#### CITY OF CEDARBURG PLAN COMMISSION March 4, 2024

#### JORDAN LARSON FINAL DETAILED PLANS

To: Cedarburg Plan Commission Prepared by: Jonathan Censky, City Planner

Agenda Item: **6.A.** Date: March 4, 2024

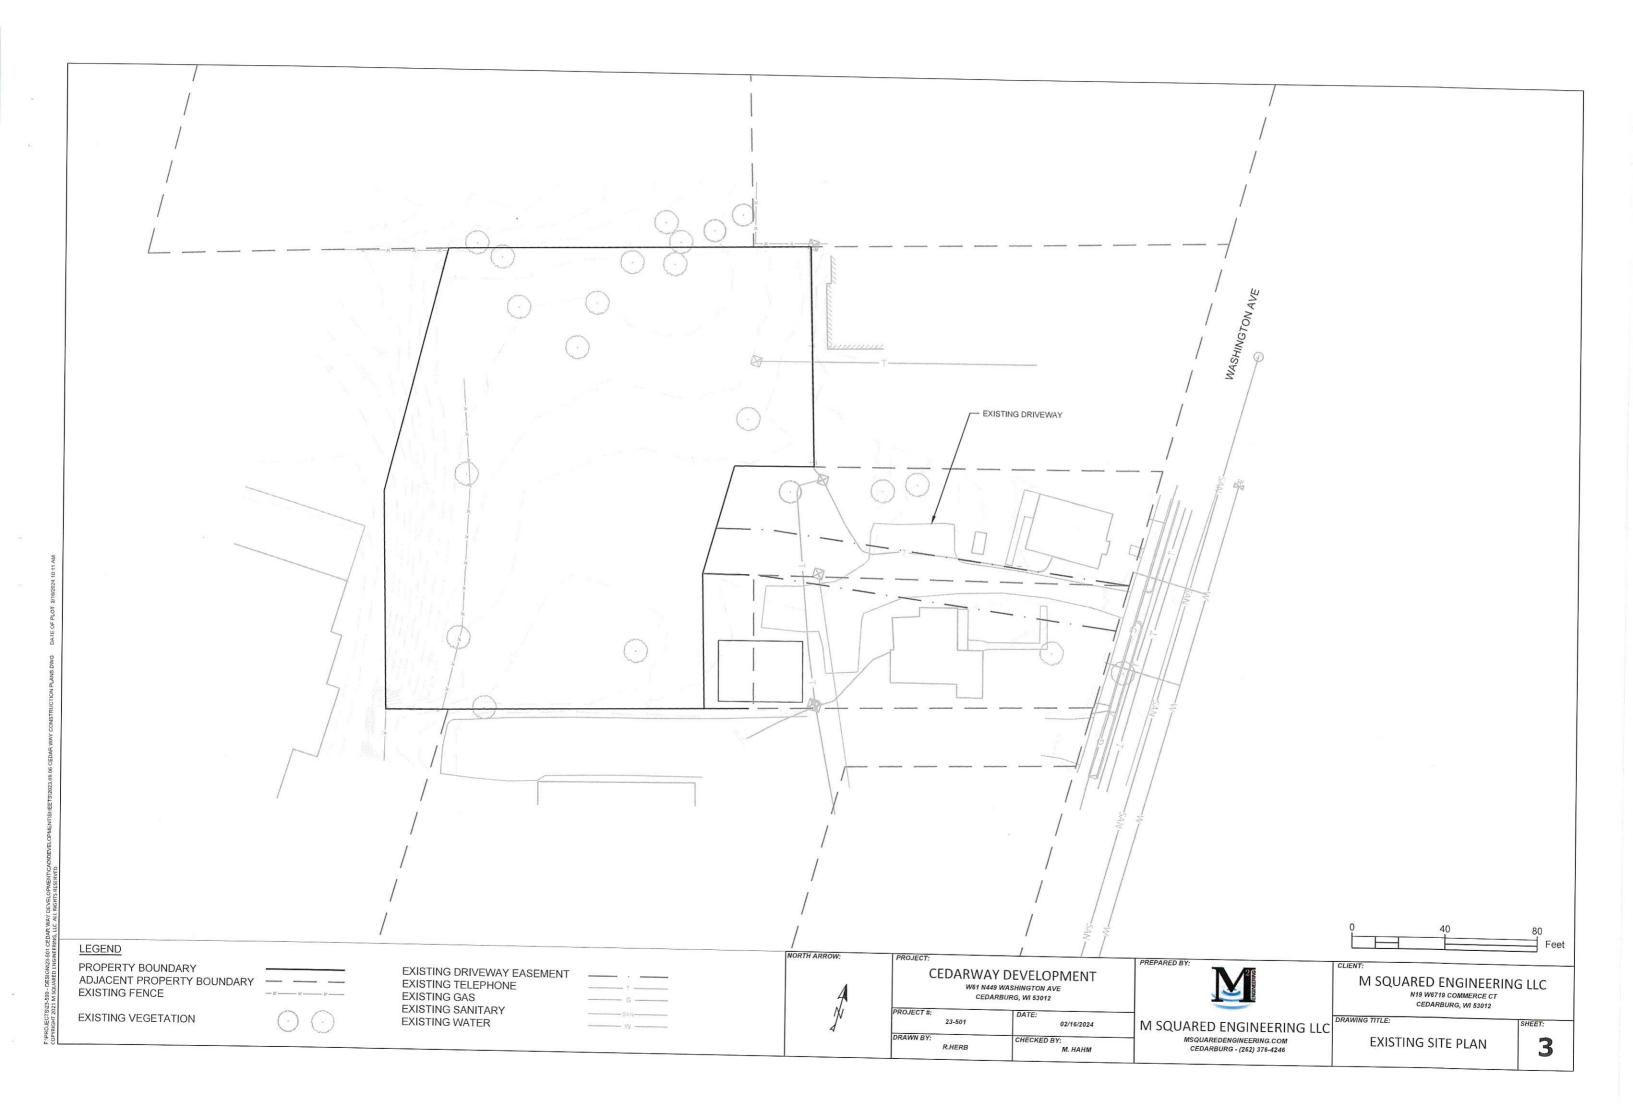
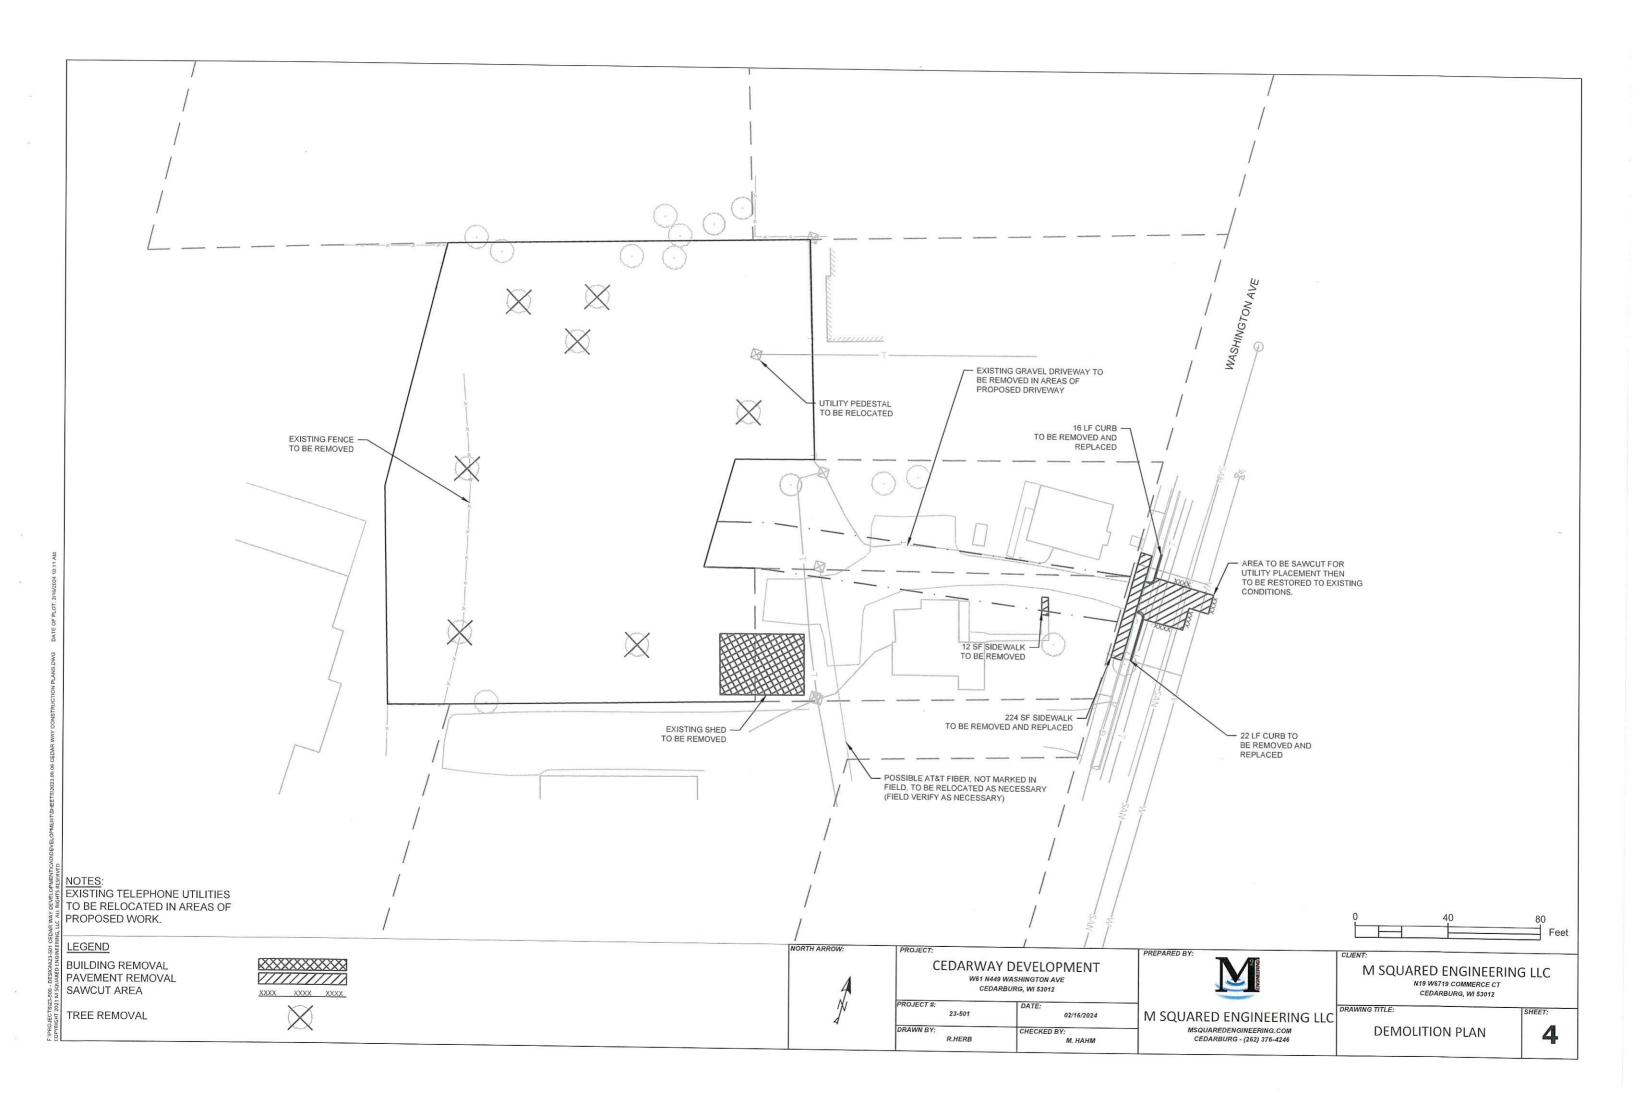
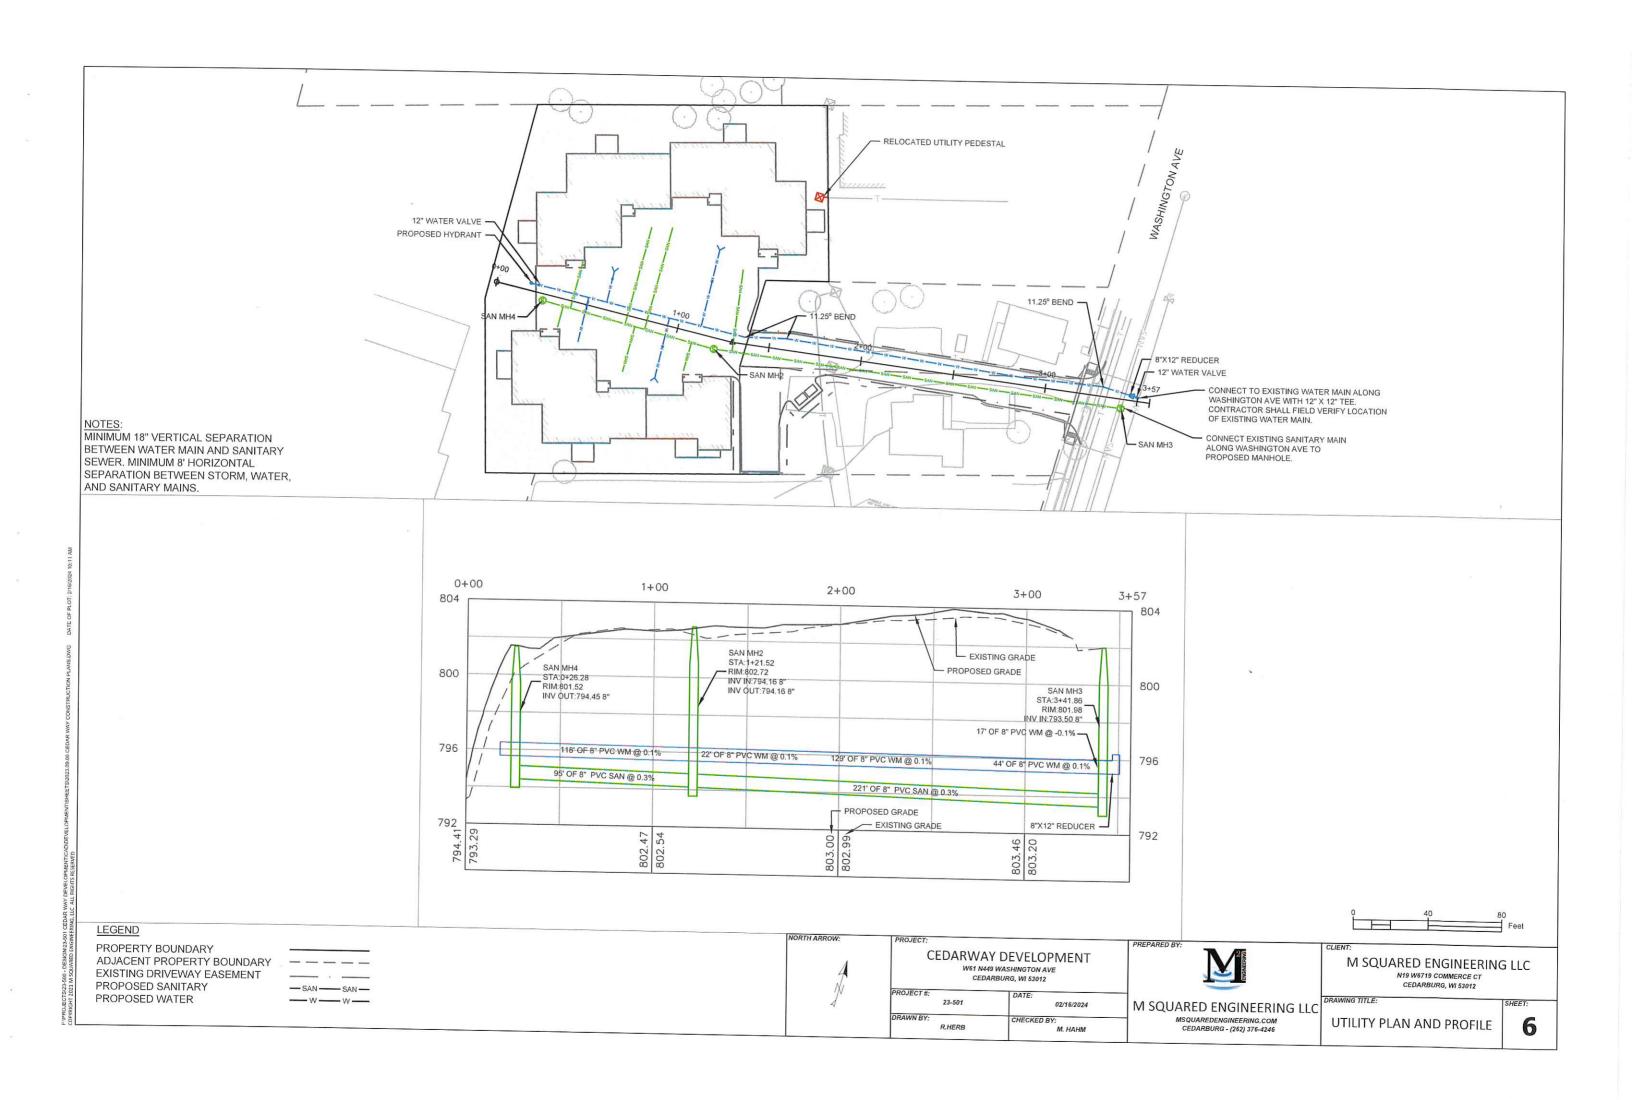
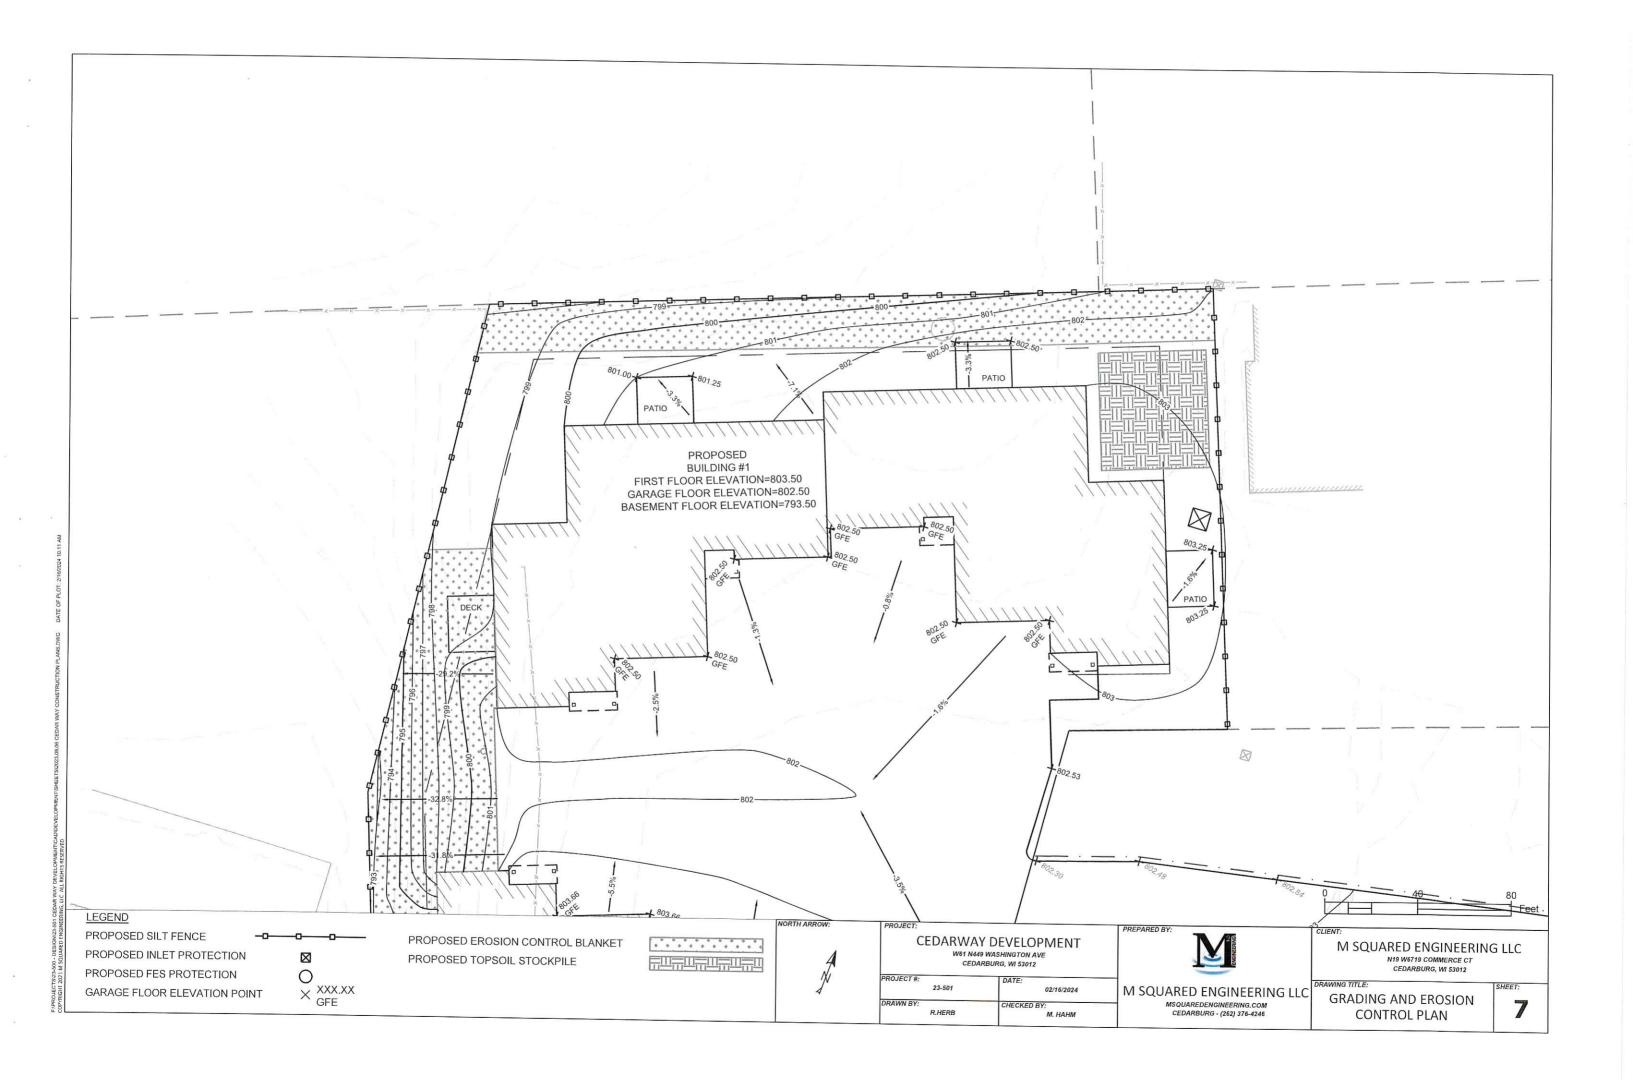
- The minimum slope of the 8" sanitary sewer pipe shall be 0.40%.
- The applicant shall show elevations of the water main.
- Staff recommends the applicant place a store water BMP at the low point in the parking lot to slow surface drainage.
- Staff recommends the parking lot to slope between 1% and 6%
- The entrance drive shall have a vertical face curb and gutter radius and a depressed head curb and gutter along Washington Ave.
- The maximum drive approach slope shall be 8%.
- The dimensional scale on pages 6-9 is wrong.
- the applicant securing Engineering department approval of the grading plans for the area along the south property line.
- The applicant shall provide a 12' wide utility easement along the north, south and west property line.
- The applicant to work with Cedarburg Light and Water for water connection issues/questions.
- Submittal of the final condominium documents.
